# INSTRUCTION SHEET

**KIT  
219-0425**

## DRIVER ASSEMBLY KIT

**FIGURE 3. INSTALLATION OF R206**

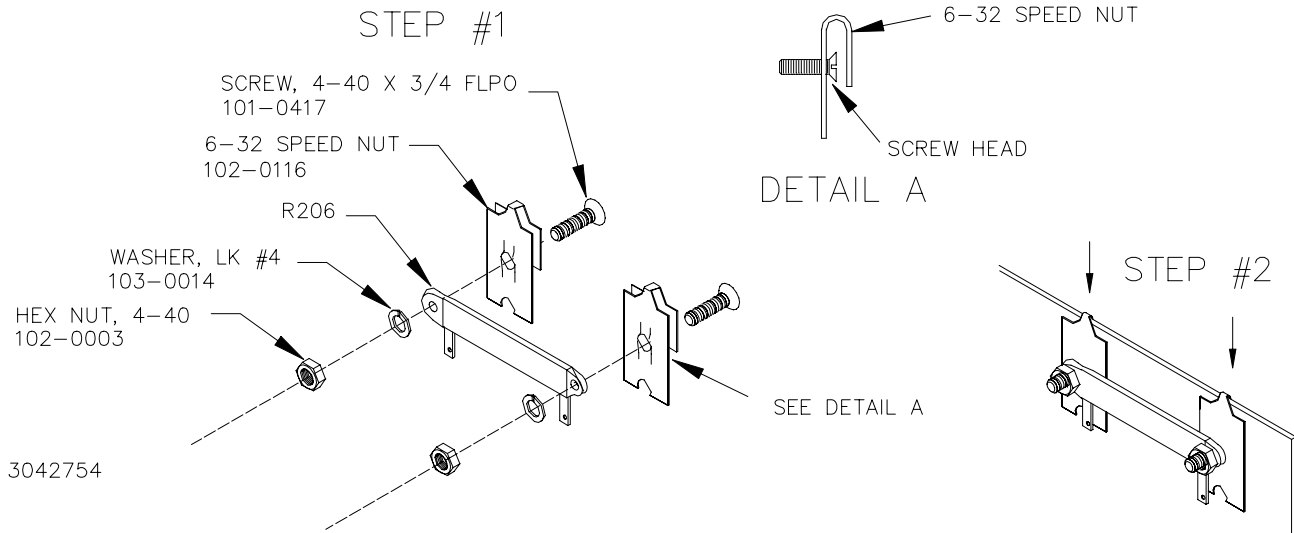
8. At rear panel, remove R205 from terminal block TB201 (see Figure 1). Install sleeving provided over leads of new R205 and install across terminals 4 and 9 of TB201 at rear panel.
9. Referring to Figure 3, step 1, assemble new R206 onto two speed nuts and secure using screws, washers and nuts provided in this kit (see Figure 3). Then press clip-on speed nuts (with R206 assembled) onto the bracket as shown in step 2.

**FIGURE 4. WIRING CHANGES**

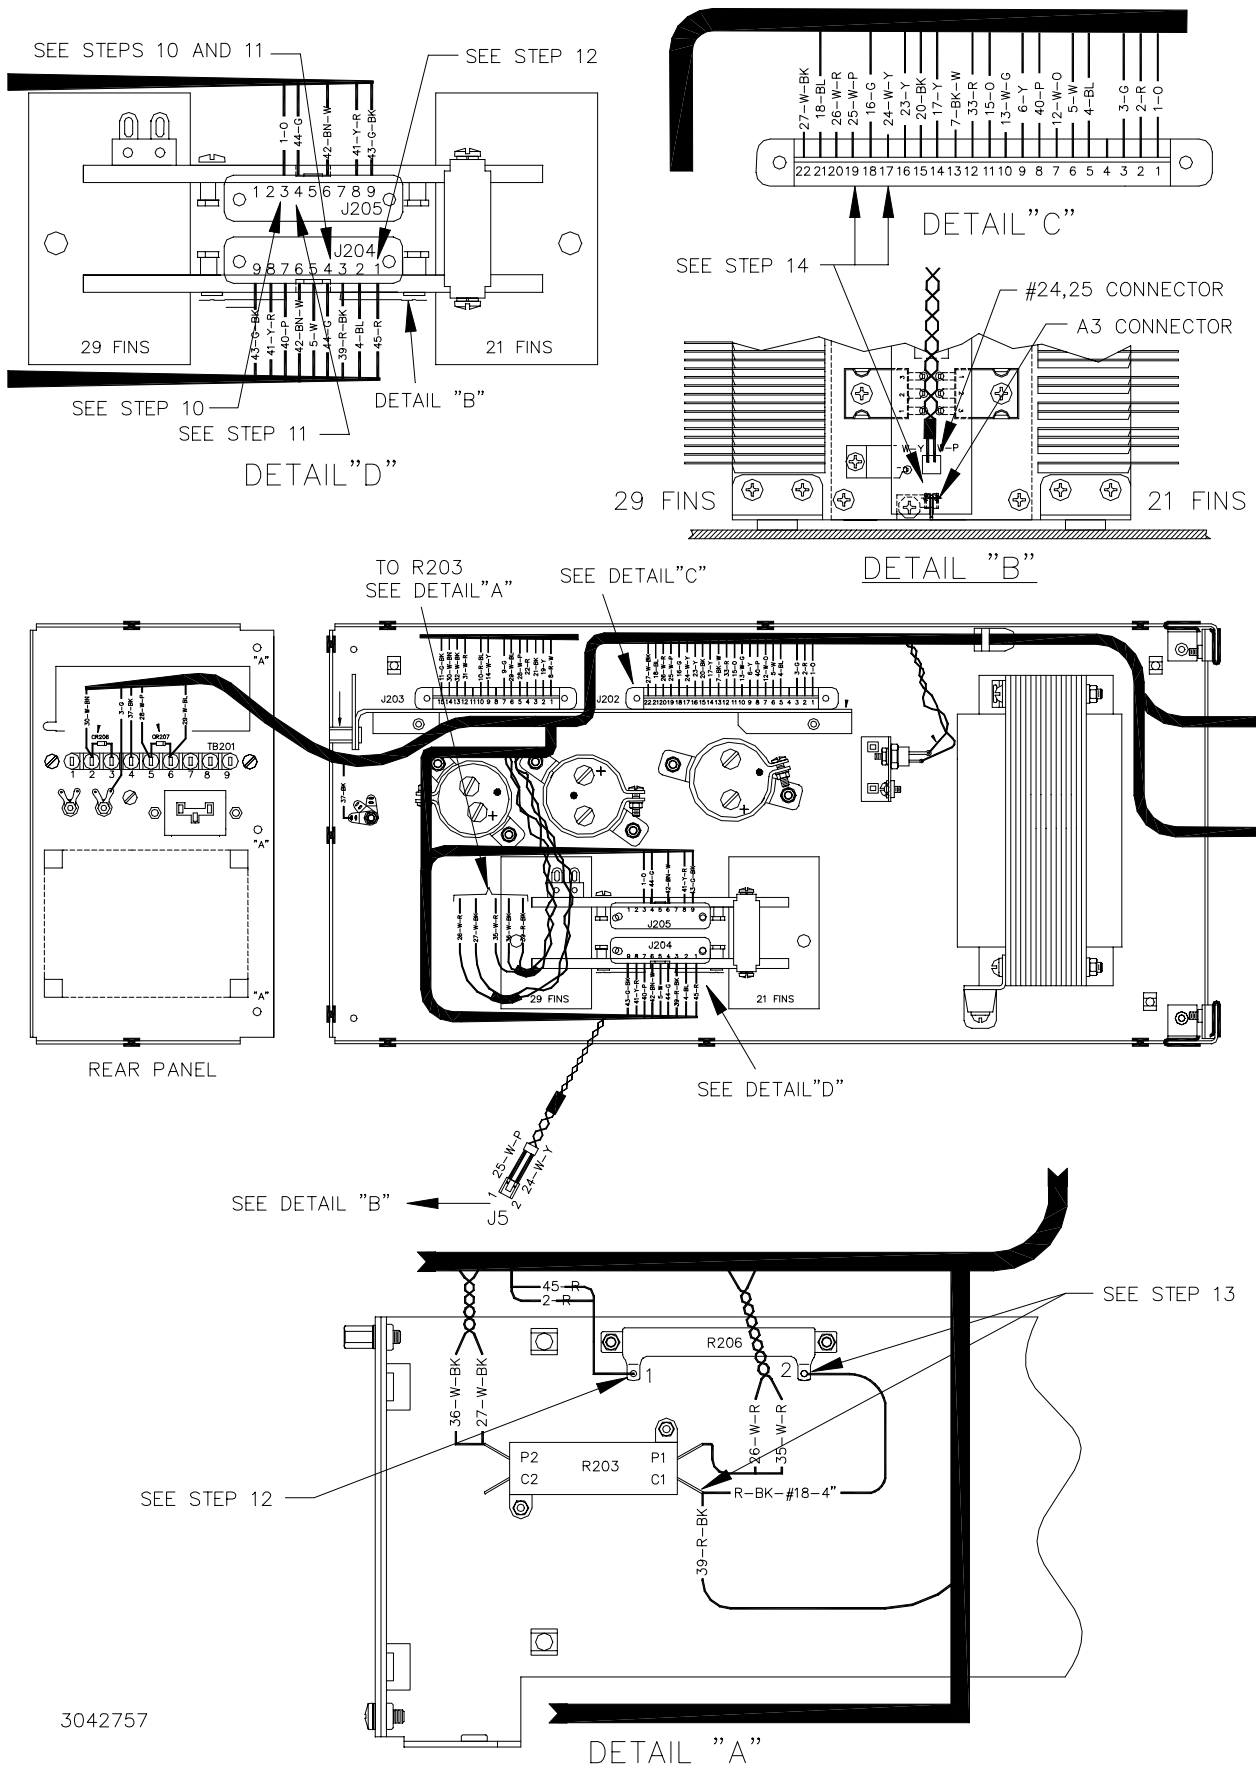
10. Refer to Figure 4 and disconnect orange wire (1-O) from connector J204 pin 4 and connect to J205 pin 3.
11. Route wire #44 (Green) along harness and connect one end to connector J204 pin 4, and the other end to connector J205 pin 4.

12. Disconnect red wire (2-R) from connector J204 pin 1. Route wire #45 (Red) along harness and connect one end to connector J204 pin 1. Connect the other end, together with red wire previously disconnected from J204 pin 1, to R206 terminal 1.

13. Connect one end of jumper (wire #18) to R206, terminal 2, and the other end to R203, terminal C1.
14. Route wire #24, 25 along harness and plug connector into A3 pass assembly at one end. At the other end connect wire #24 (White-Yellow) to J202 pin 17 and wire #25 (White-Purple) to J202 pin 19.
